REPUBLIC AVIATION CORPORATION
FARMINGDALE, LONG ISLAND, NEW YORK
SERVICE DEPARTMENT

SERVICE BULLETIN NO. 17

INSTALLATION STEERABLE TAIL WHEEL

Reason for Change: To provide greater ease of taxiing under crosswind conditions.

Figure 1
Yoke Rework

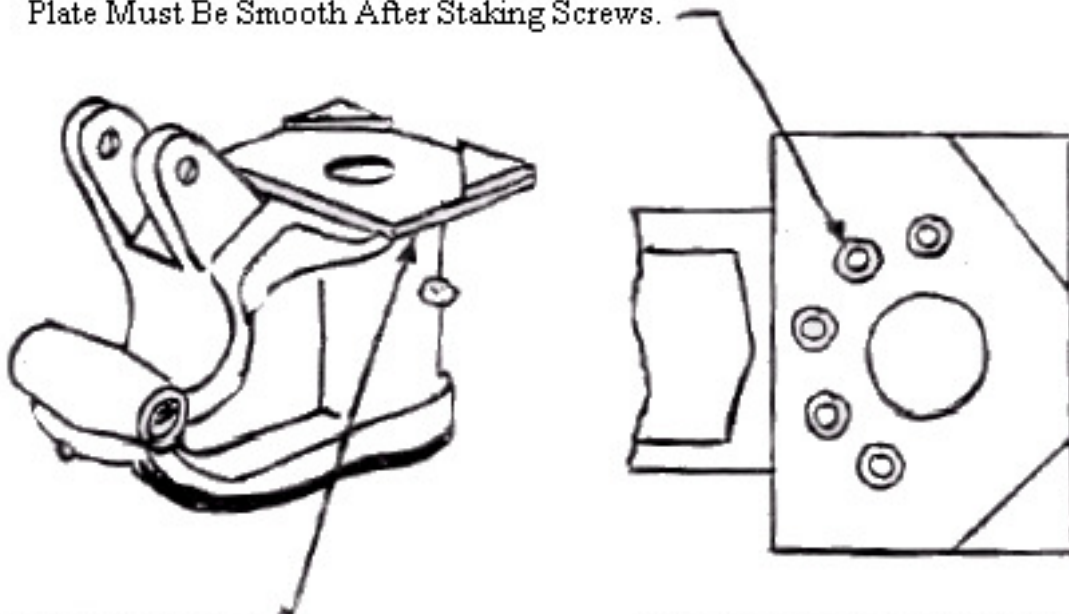
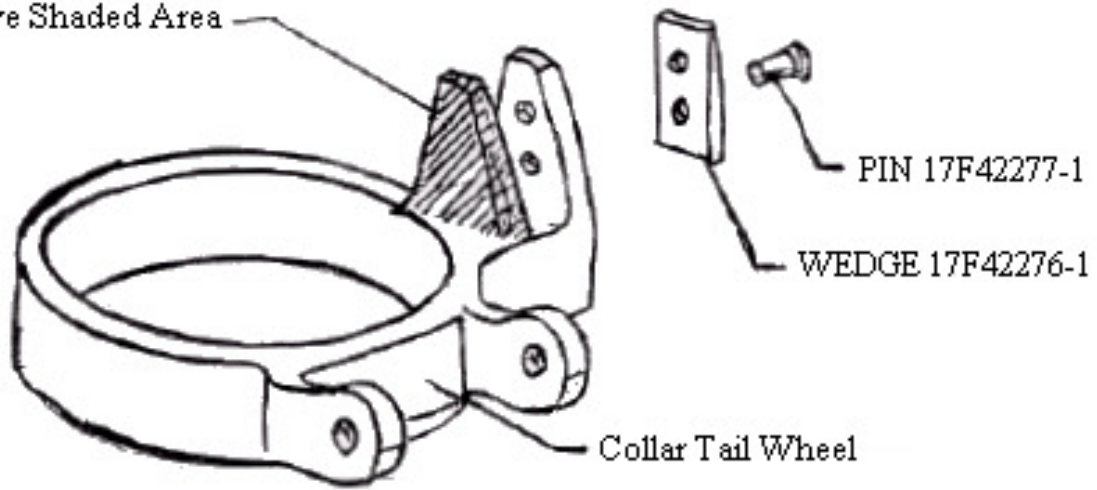
1. Rework the yoke assembly in accordance with Figure 1. It will be noted that this rework consists of removing the top portion of the yoke, which was previously used to support the lock pin aft pulley. It is suggested that this material be removed with a hacksaw and then file smooth to existing flat counterbore. Be sure to cover needle bearings to prevent chips, etc. from getting on them.

2. Place Cam Assembly 17F42180-1 on top of yoke so that center of holes in cam and yoke line up within +.005 inches. Using pilot holes in cam as guides drill five holes #26 (.147) 3/4 inch deep into yoke enlarging pilot holes in cam at same time. Tap holes in yoke and cam #10-24-5/8 inch deep (NC-2). Countersink holes on top of cam .372 inch diameter by 82°. Attach cam to yoke using five AN505C10-8 screws. Stake these screws in place. The top surface of the cam plate must be smooth after staking the screws. Refer to Figure 1.

NOTE:
REMOVE SHADED AREA TO EXISTING FLAT SURFACE AS SHOWN

Drill #26 (.147) -3/4" Deep in Yoke and Cam - Tap #10-24-5/8" Deep (NC-2)
Countersink .372" Dia x 82°. 5 Holes Equal Spaces as Shown.
AN 505-C10-8 Screws (5) Stake in Place - Surface of Cam.
Plate Must Be Smooth After Staking Screws.

Figure 2
Collar Rework

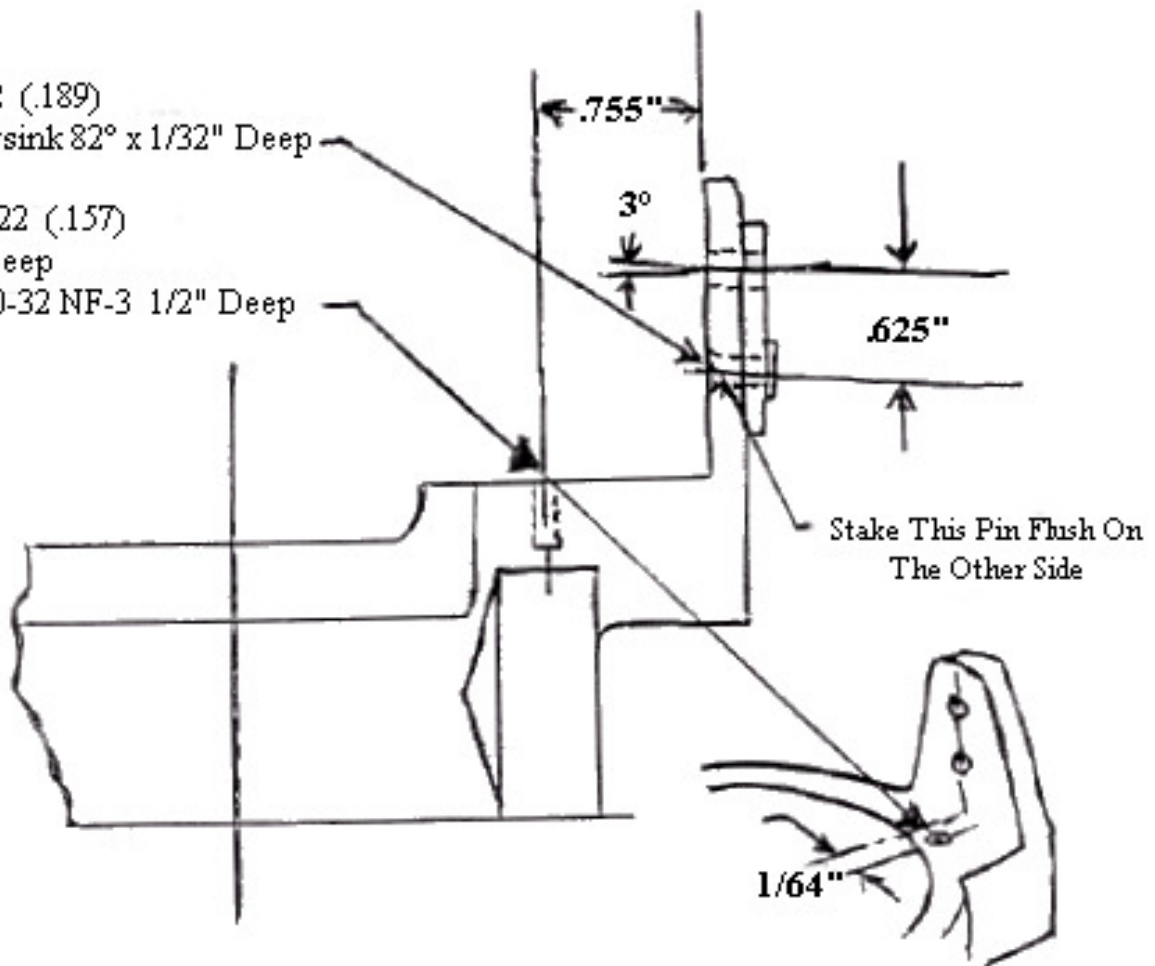
1. Rework aft shock absorber collar in accordance with Figure 2. This work can be accomplished with collar in place. This rework consists of removing the inboard ear on the collar. This ear may be removed with a hacksaw and filing smooth. Also note that a #22 (.157) 5/8 inch deep hole must be drilled and tapped #10-32-1/2 inch deep (NF-3) into side of collar.
2. Place Wedge 17F42276-1 on outboard side of ear on collar as shown in Figure 2 so that centers of pilot hole in wedge and hole in ear line up. Using full size #12 (.189) hole in wedge as guide drill #12 (.189) through ear on collar. Countersink

hole on inboard side of ear 82° by 1/32 inch deep as shown. Attach wedge to ear with 17F42277-1 pin, staking pin on inboard side and filing smooth if necessary. Using pilot hole in wedge as guide drill and ream ¼” (.250) through wedge and ear normal (perpendicular) to outboard surface of wedge.

Remove Shaded Area

Drill #12 (.189)

Countersink 82° x 1/32" Deep

Drill #22 (.157)

5/8" Deep

Tap 10-32 NF-3 1/2" Deep

Figure 5

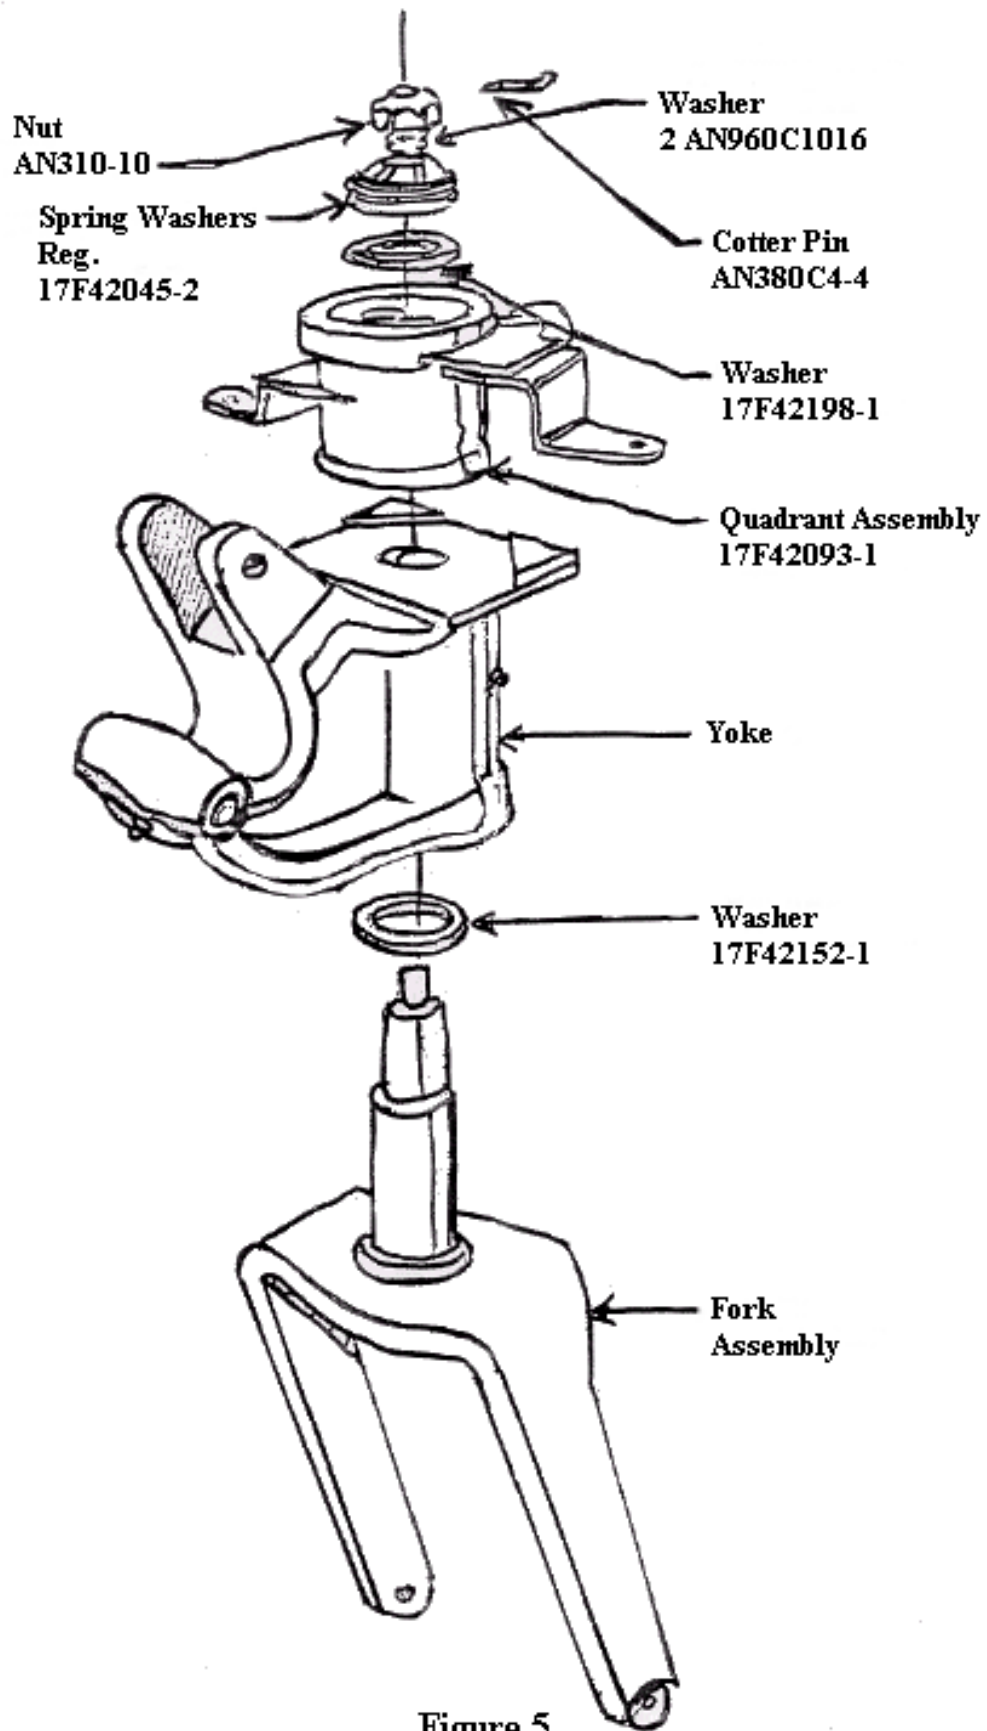
1. Referring to Figure 5 assemble yoke and quadrant assemblies on Fork and Spindle assemblies as follows:
 - a. Place 17F42152-1 washer over spindle.
 - b. Place yoke assembly over spindle.
 - c. Place Quadrant Assembly 17F42093-1 with Bushing Assembly 17F42175-1 over spindle.
 - d. Place Washer 17F42198-1 over spindle.
 - e. Place two Spring Washers 17F42045-2 over spindle.
 - f. Fasten assembly together with two AN960-C1016 washers, one AN310-10 nut and AN380-C4-4 cotter pin tightening nut sufficiently to resist a 20# to 25# side load applied at the bottom of the fork.
 - g. Apply AN-G-15 or equivalent waterproof grease at lubricating fittings on yoke.
 - h. Assembly old wheel, tire, etc. on this assembly.

Figure 6

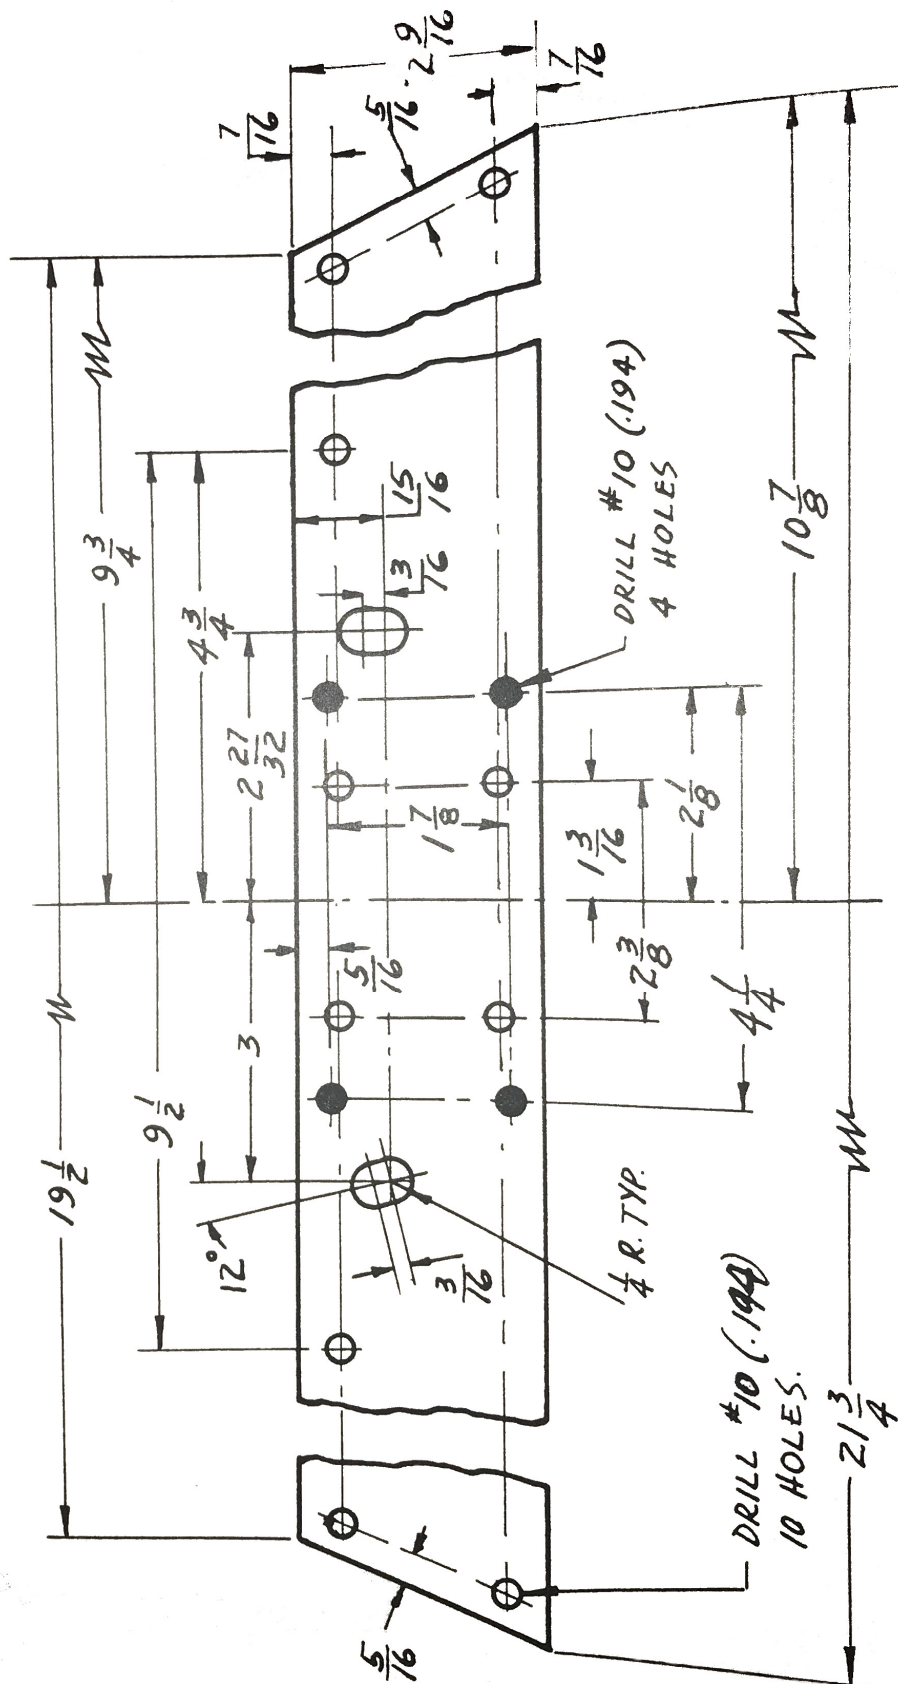
1. Make up drilling template to use for installing pulley bracket at Station 230.5 as shown in Figure 6. This template may be used to drill holes through bulkhead due to lack of visibility. Use a piece of 21-3/4 x 2-9/16 x 1/8 Aluminum for this. If a large number of ships are to be reworked with the same template, it is recommended that steel be used. While making template check it against the bracket, pulley and cable assembly for alignment for holes.

Figure 7

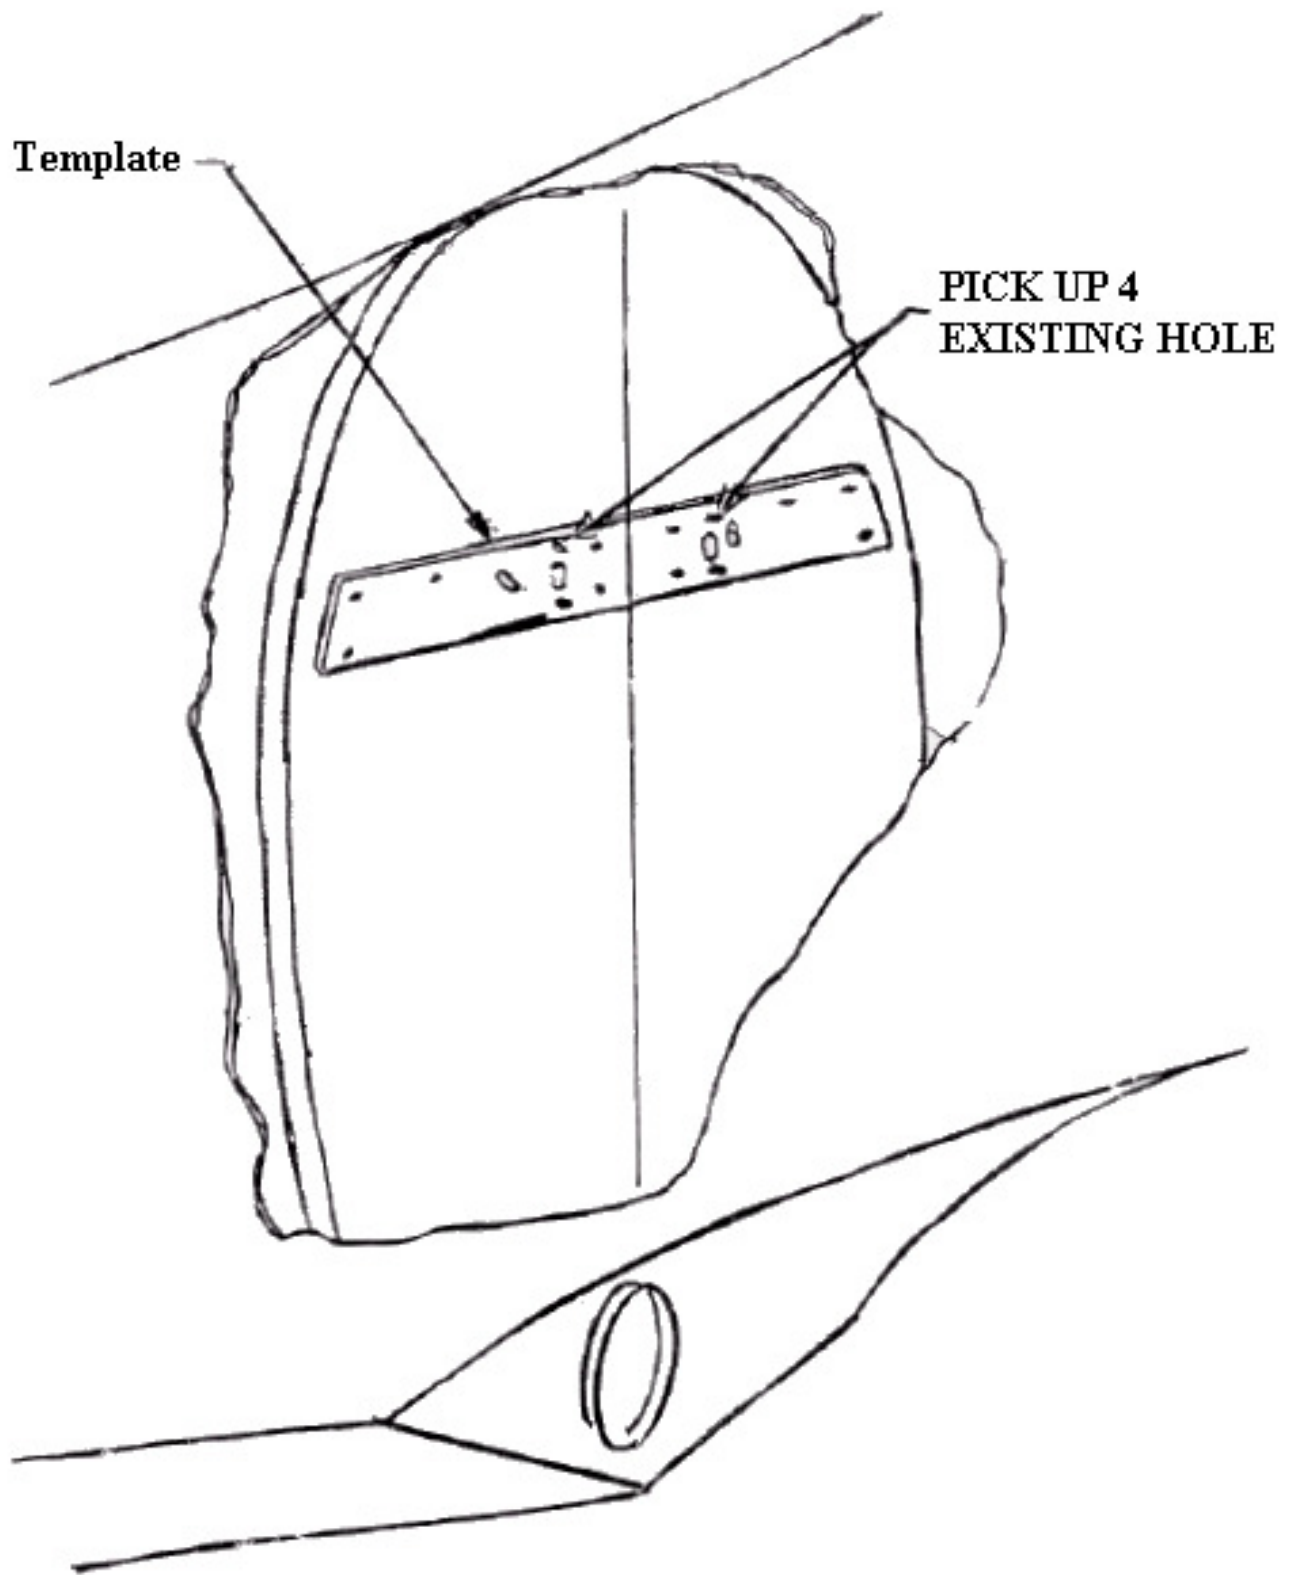
4. Place drilling template in place on aft side of bulkhead Station 230.5 referring to Figure 7 holding it in place with four bolts at existing fairlead holes and drill ten #10 (.194) holes through diameter holes through bulkhead using elongated holes in template as guides. Use a rotary or rat-tail file to open these holes up to full elongated size. Remove template.

Figure 8

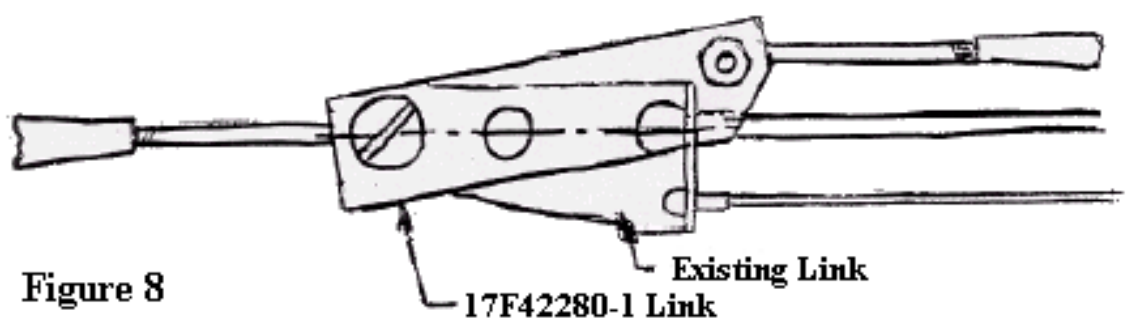
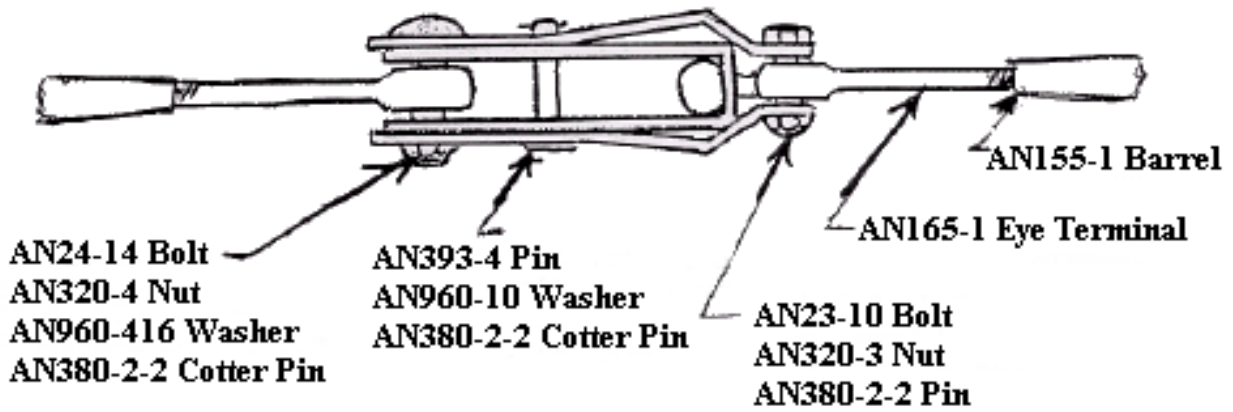
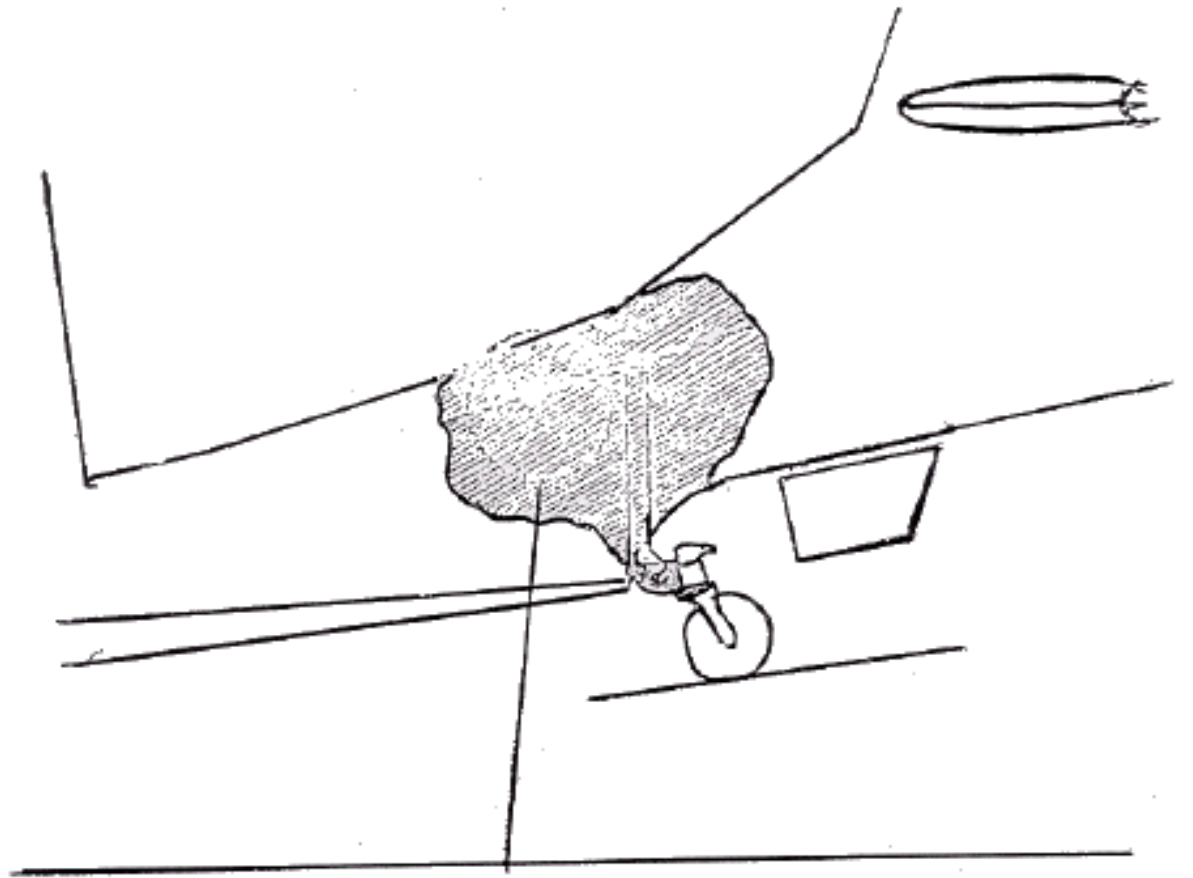
3. Disconnect rudder and water rudder control cables at rudder cross tubes in cabin. Then remove bolts holding cables to link at point shown on Figure 8. Pass aft cables through bulkhead Station 230.5. This will necessitate removal of the fairlead at this point.

- bracket assembly to bulkhead with ten AN3-4A bolts, AN365-1032 nuts and AN960-10 washers.
6. Clamp a left and right Link 17M42280-1 on either side of original links as shown on Figure 8 and drill #12 (.189) holes through original links using holes in new link as guides. Fasten new links to old links with AN393-21 pin, AN960-10 washer and AN380-2-2 cotter pin.

8. Reinstall reworked links as shown in Figure 8 using AN24-14 bolt, AN320-4 nut and AN960-416 washer and AN380-2-2 cotter pin for each link. Reconnect cables at crosstube in cabin.

9. Attach each forward end of new steerable tail wheel control cables to links using an AN155-16L barrel, AN165-16L eye terminal, AN23-10 bolt, AN320-3 nut and AN380-2-2 cotter pin. Refer to Figure 8.
